ADDENDUM NO. 1 ELEMENTARY ADDITION TO SUMTER CENTRAL HIGH SCHOOL

Architect Job No. 24-38 July 24, 2024 DCM # 20240619

PROJECT:	PROJECT NO.	REFERENCE:
ELEMENTARY ADDITION TO SUMTER CENTRAL HIGH SCHOOL	24-38	ADDENDUM NO. 1
ARCHITECTURAL ADDENDUM DRAWING	DATE:	SHEET NO.
ANCHITECTORAL ADDENDOW DRAWING	7/10/2024	ADD 1

1 MECHANICAL - ROOF PLAN - PART C

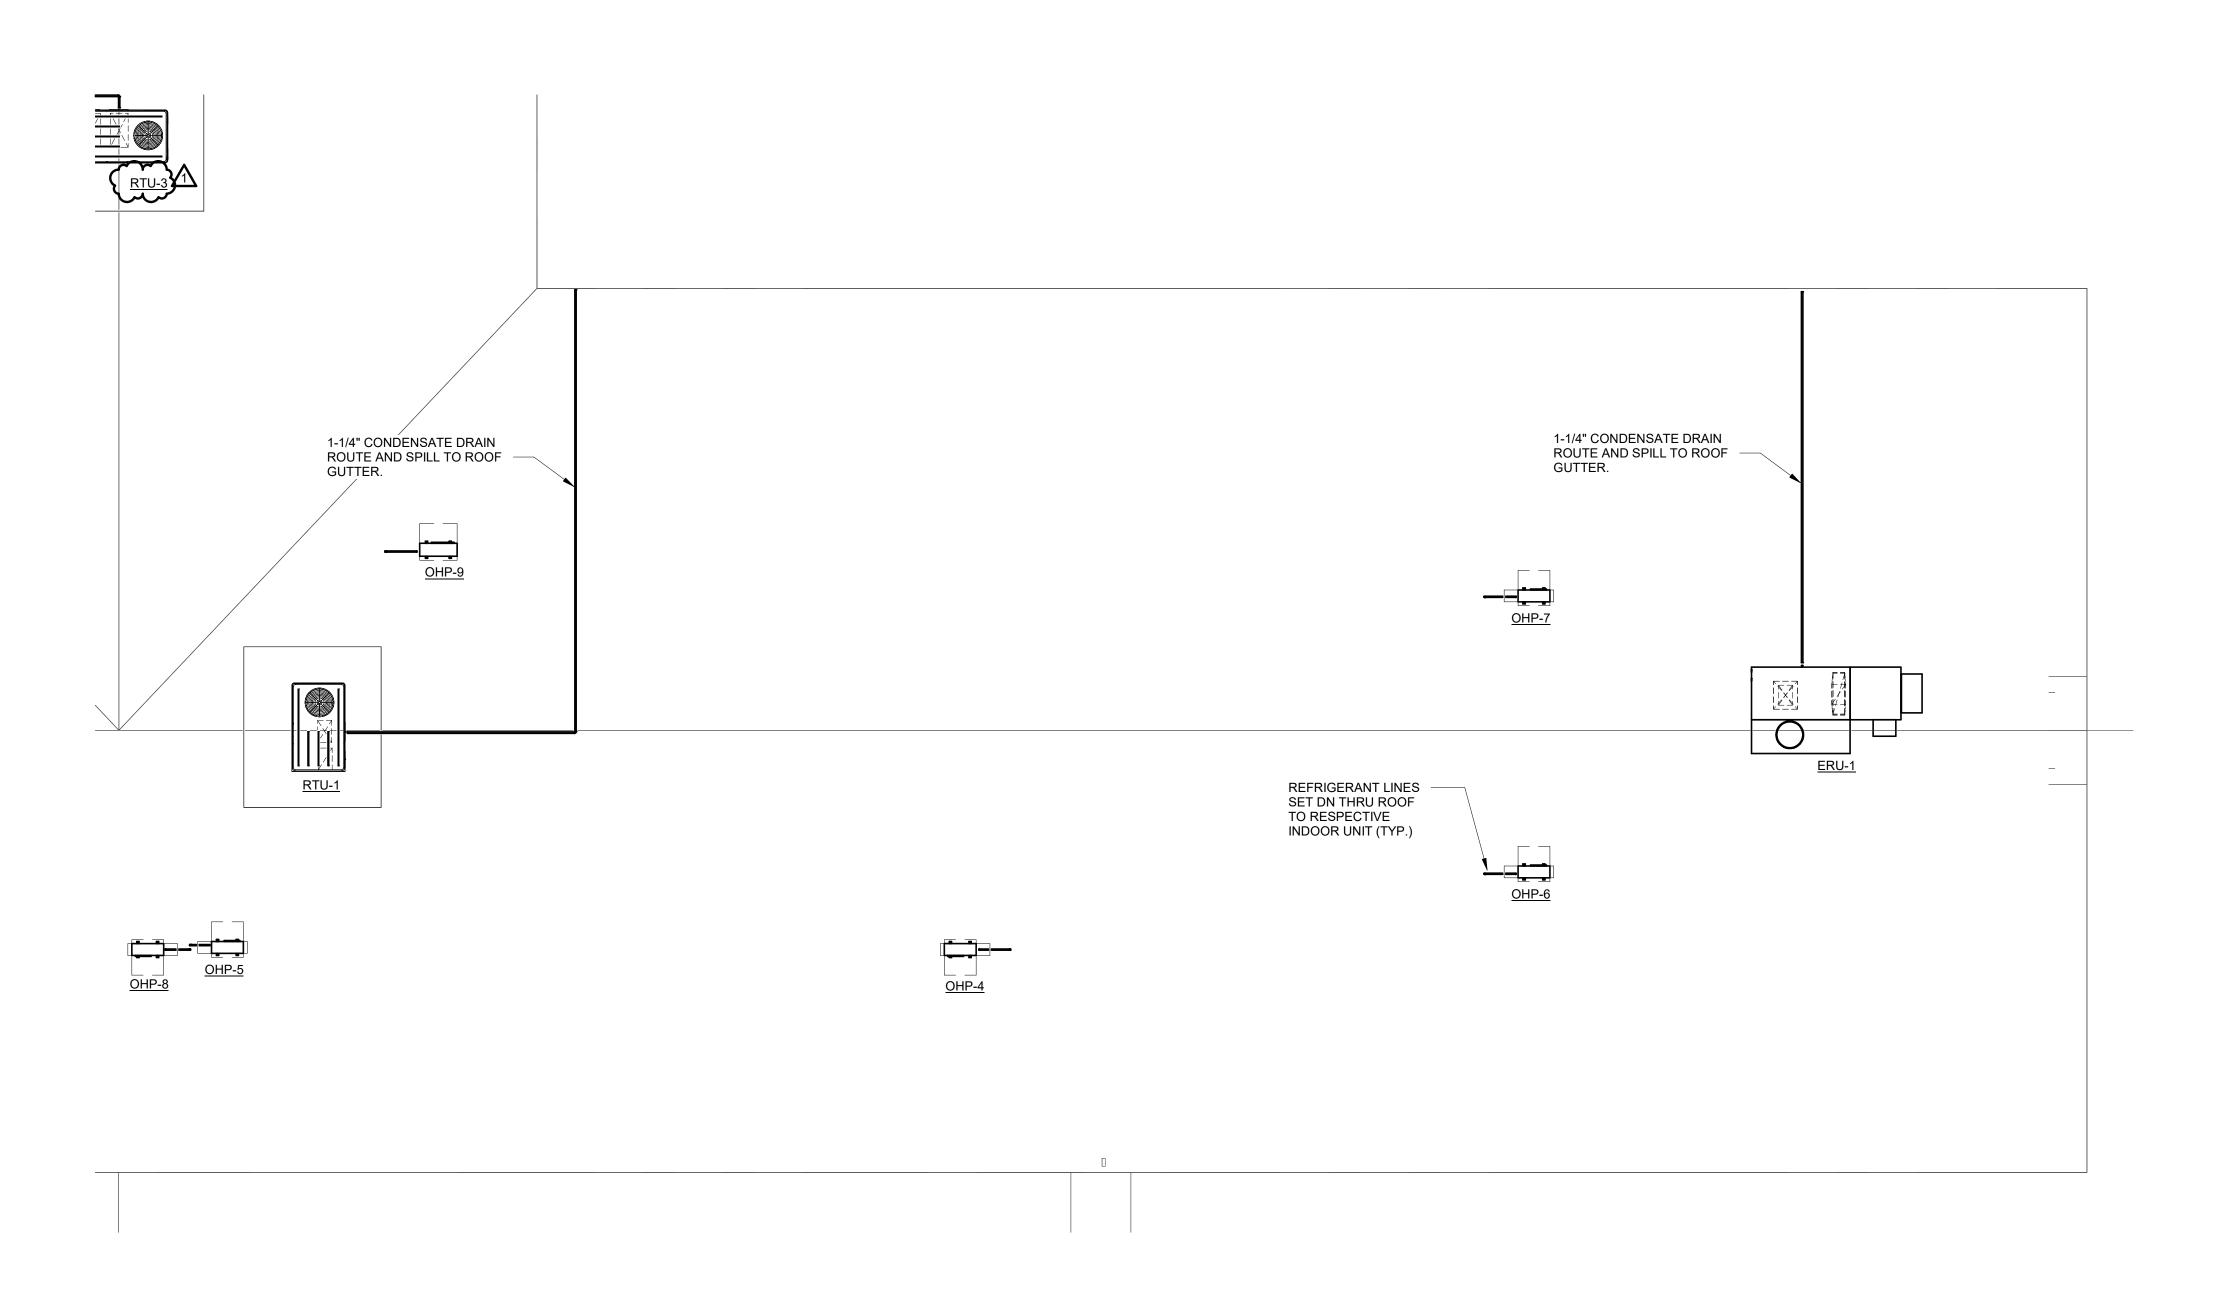
- 12. See attached Sheet **M2.1** revised Mechanical Roof Plan B.
- 13. See attached Sheet **M2.2** revised Mechanical Roof Plan C.
- 14. See attached Sheet **M3.0** revised Mechanical Piping Floor Plan Part A.

1 FIRE PROTECTION - FLOOR PLAN - PART C

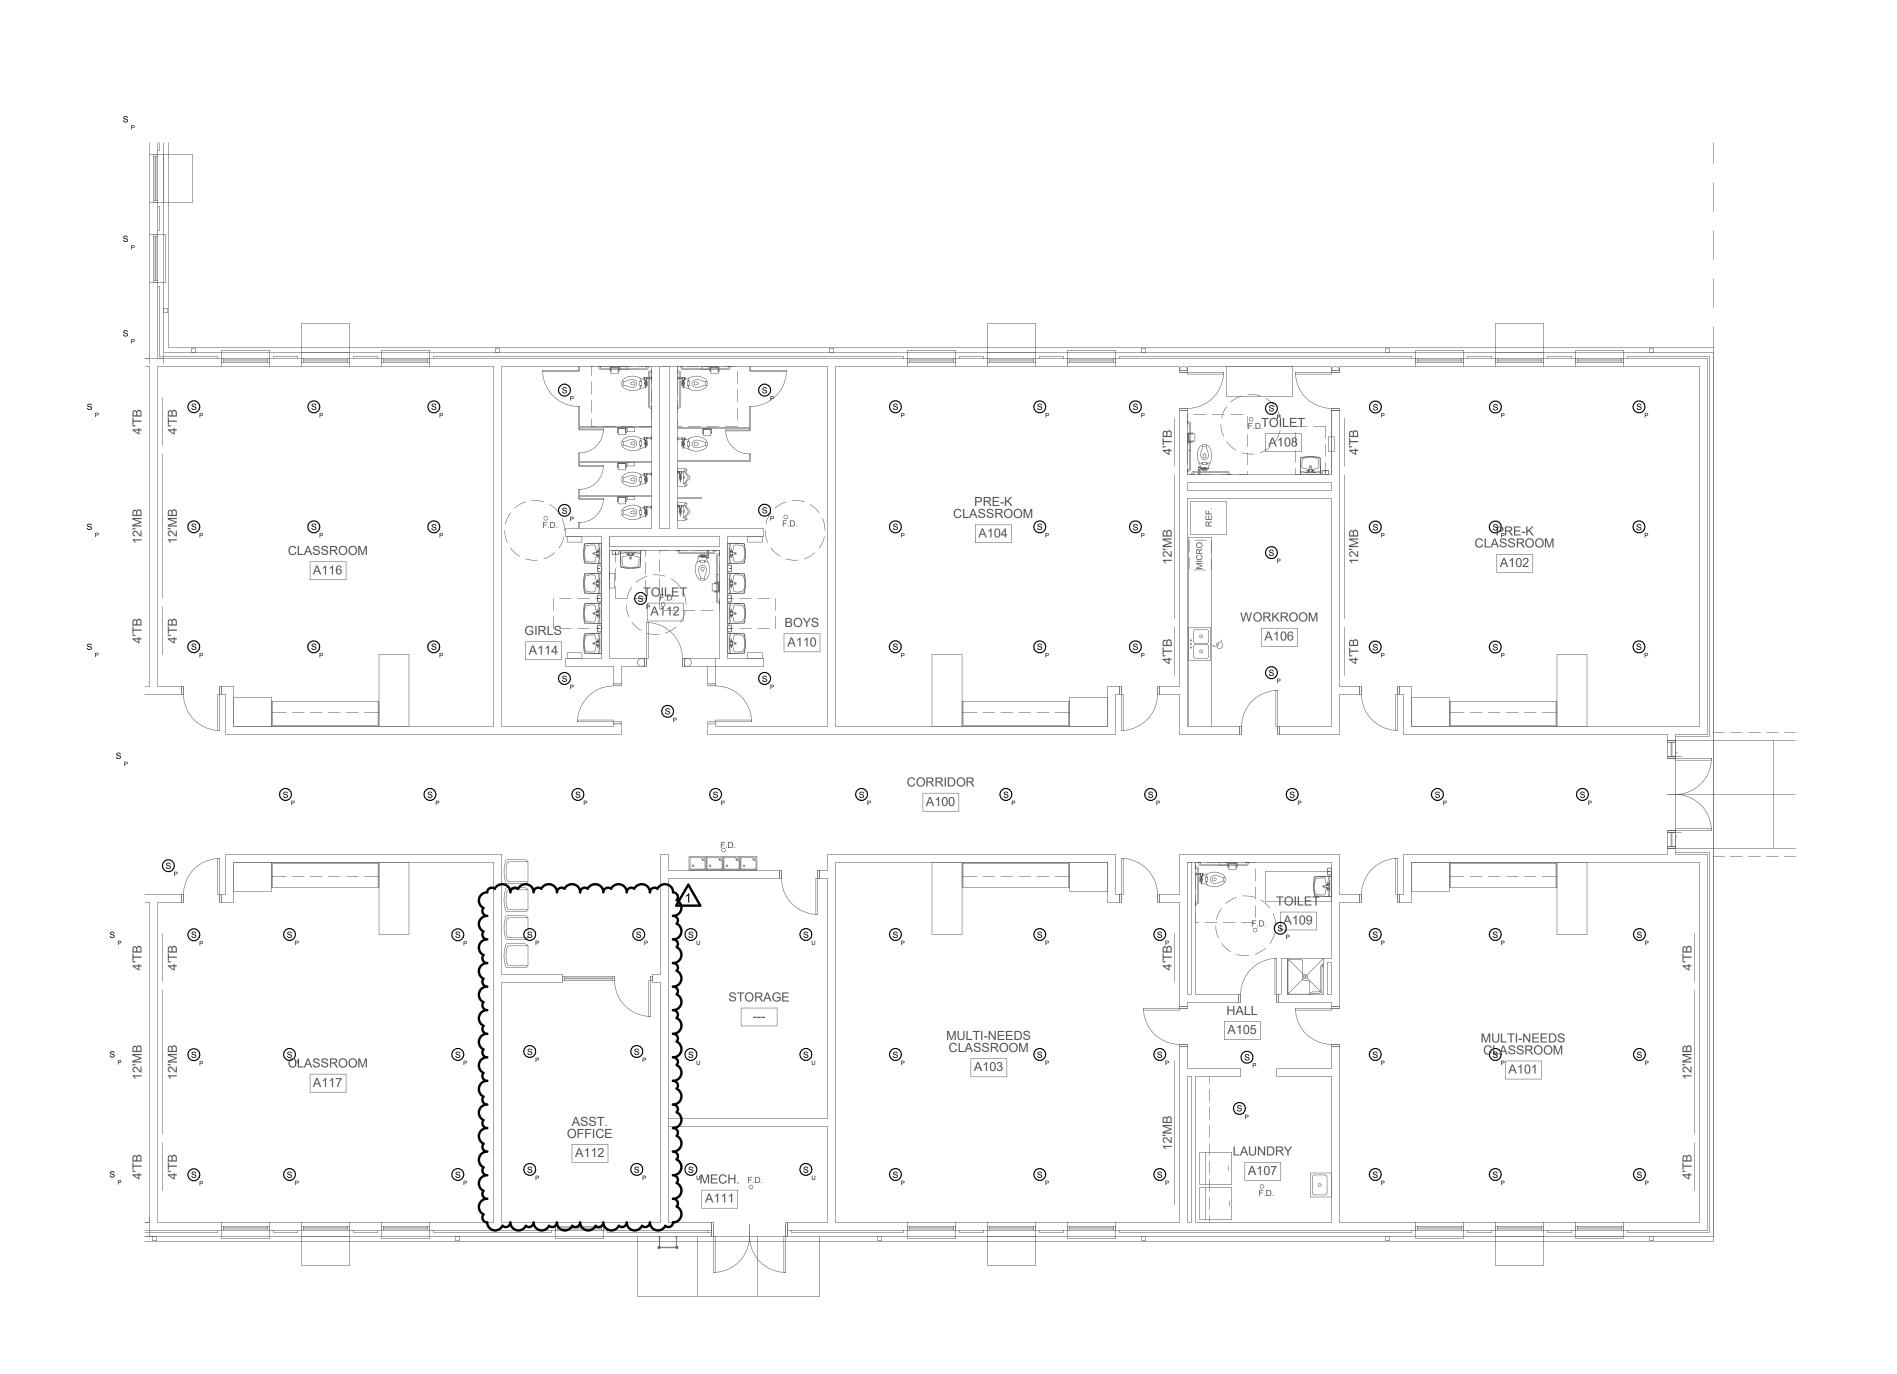
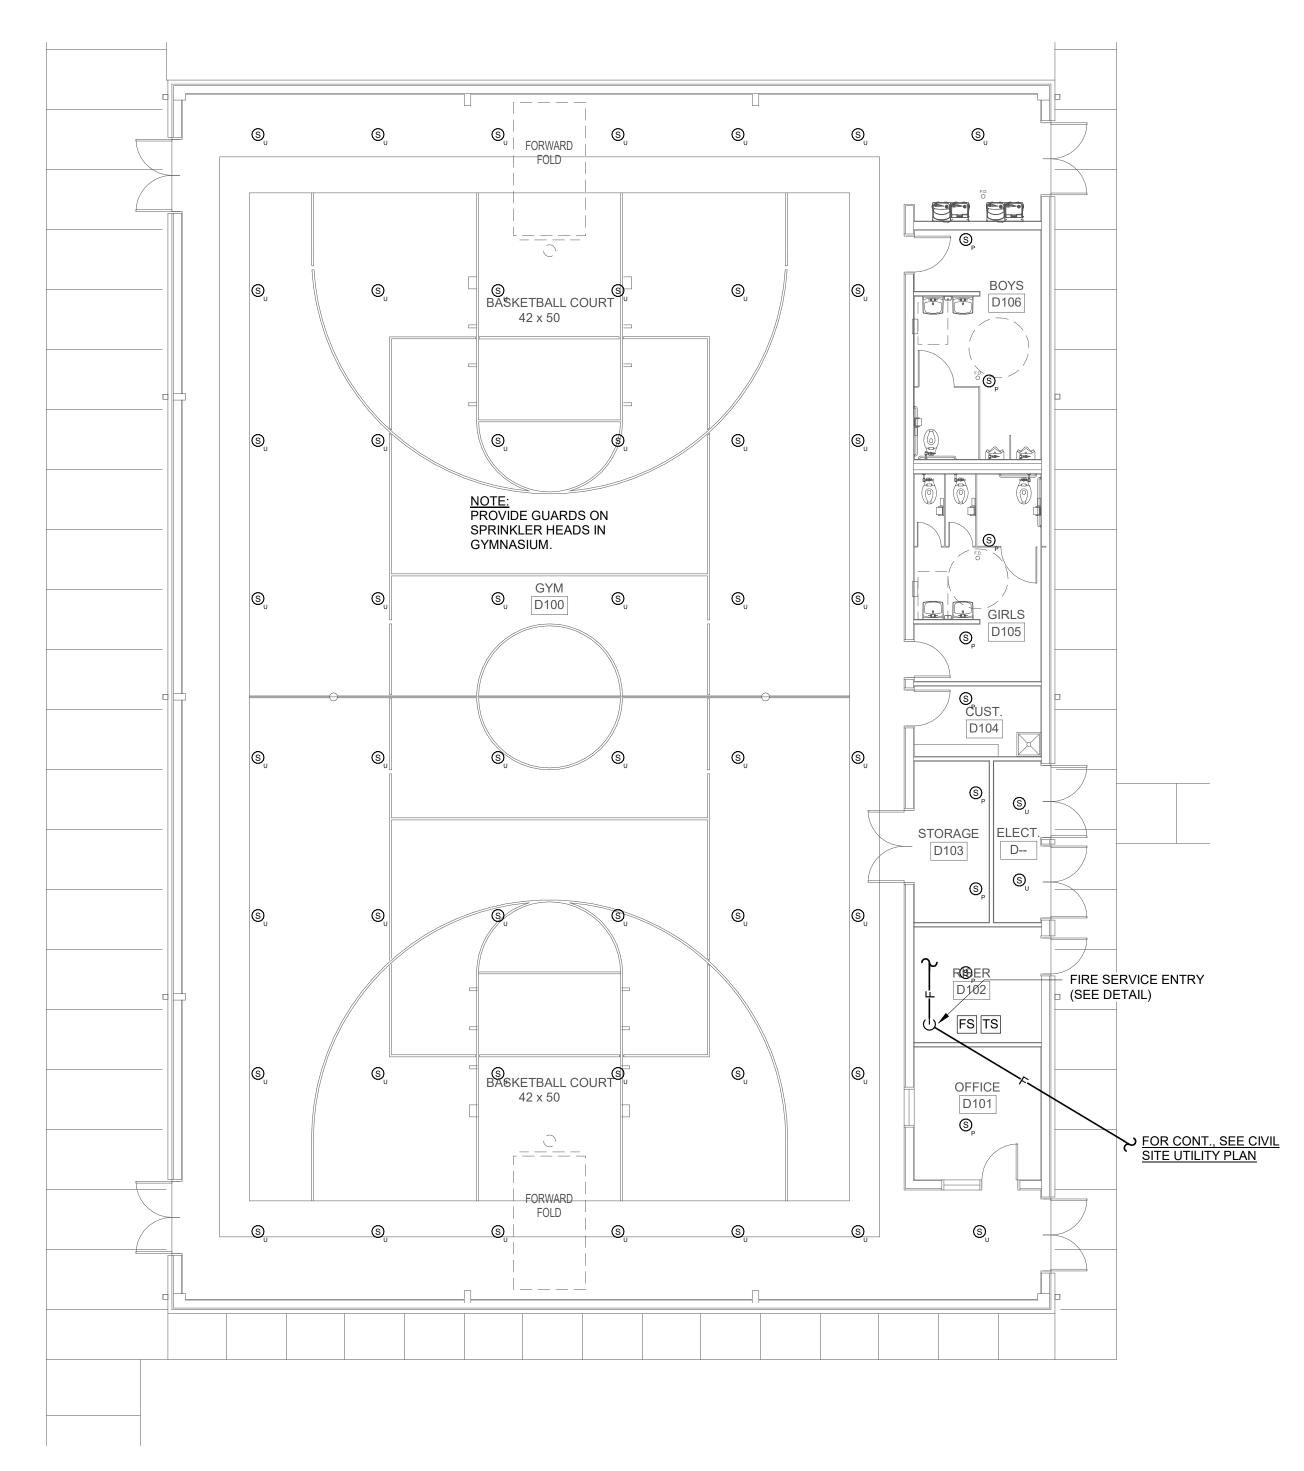
- 17. See attached Sheet **FP0.2** and **FP0.3** for Fire Pump Details.
- 18. See ASST. OFFICE A112 on attached Sheet **FP1.1** for revisions to Fire Protection Floor Plan Part C.

SHEET NO:
P1.0

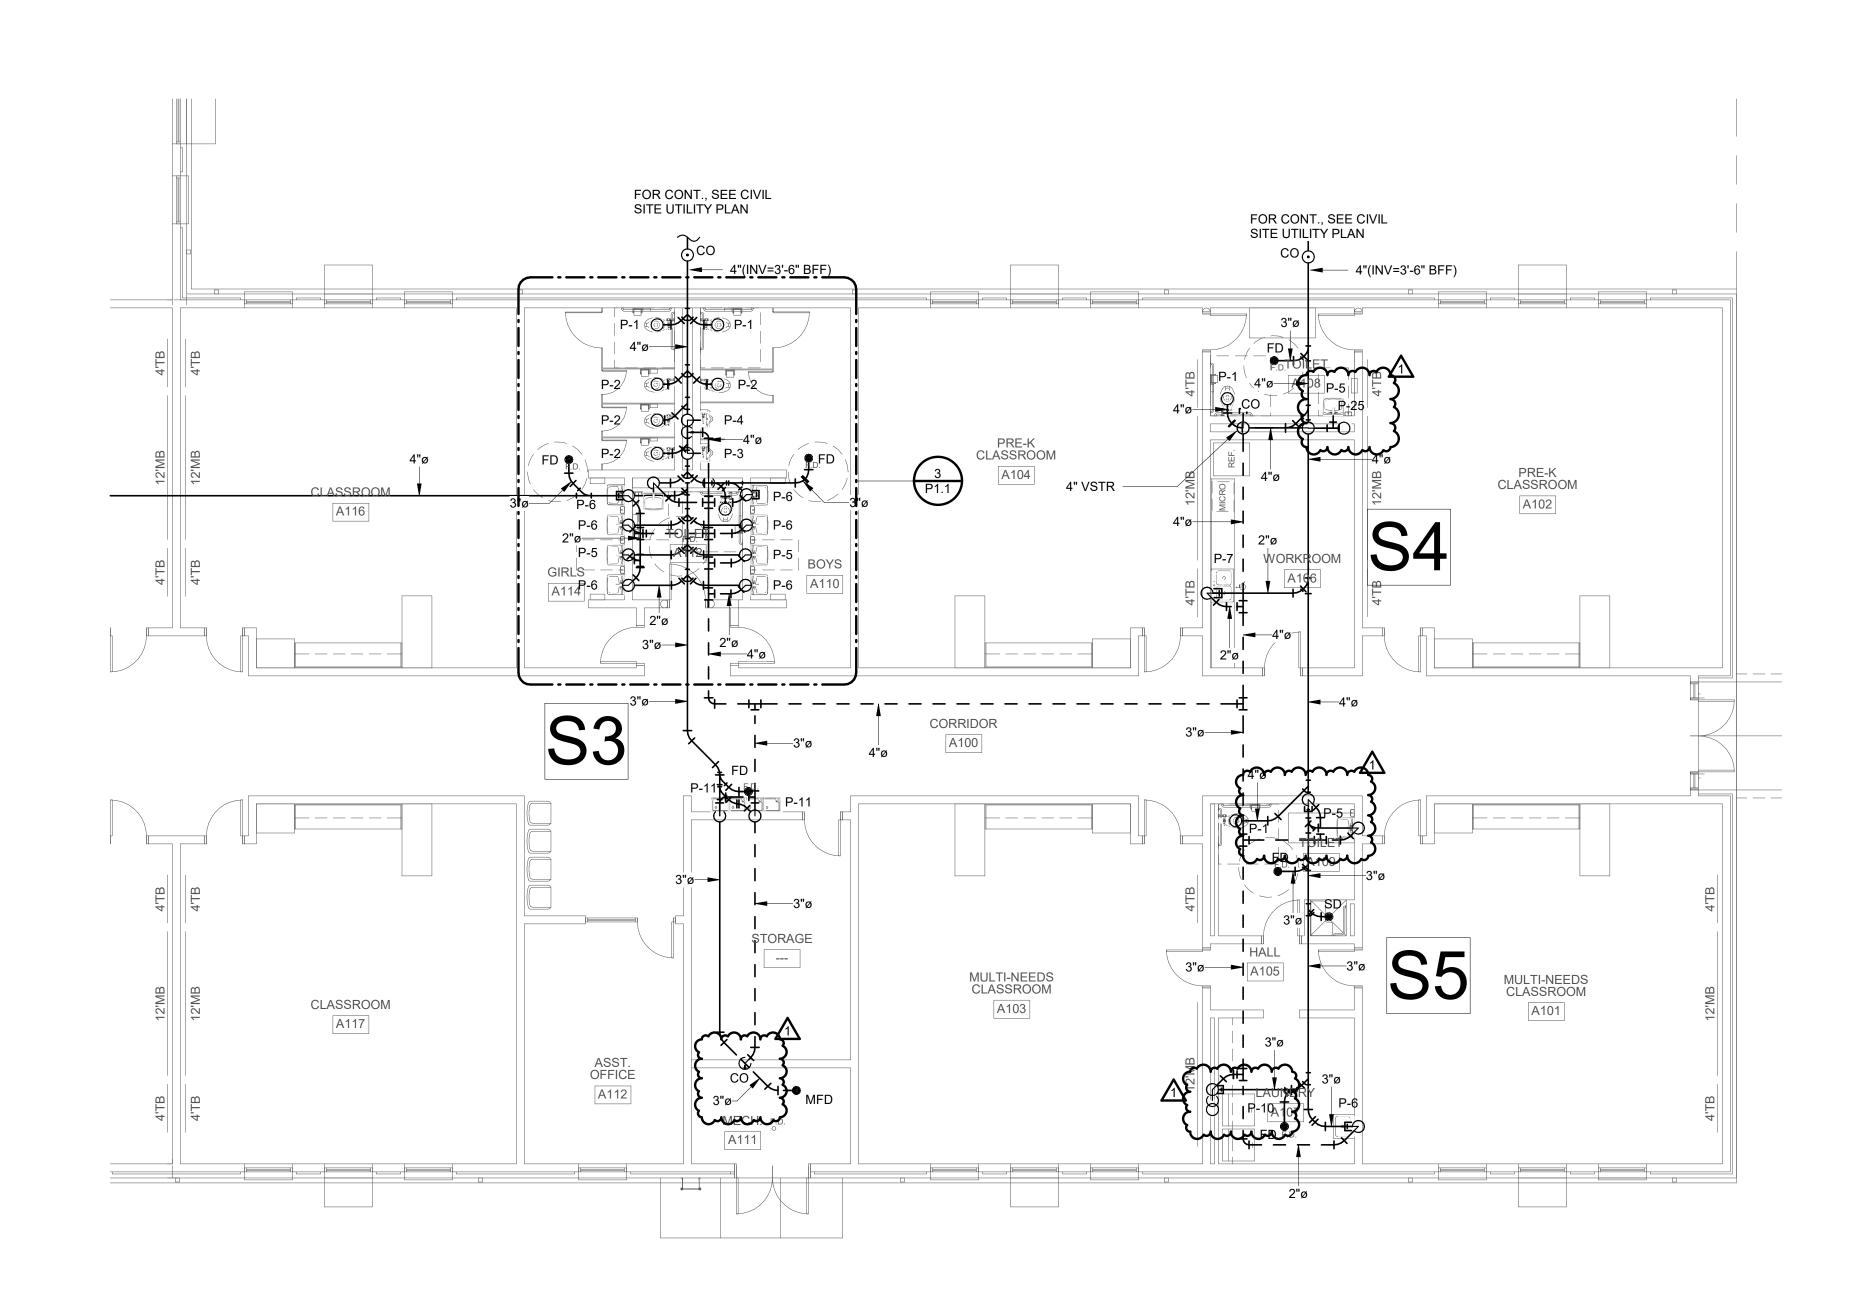
- 19. See attached Sheet **P0.01** for revised Water Heater Schedule.
- 20. See attached Sheet P1.0 for revised Non-Pressure Piping Floor Plan Part B.
- 21. See attached Sheet **P1.1** for revised Non-Pressure Piping Floor Plan Part C & Gym.
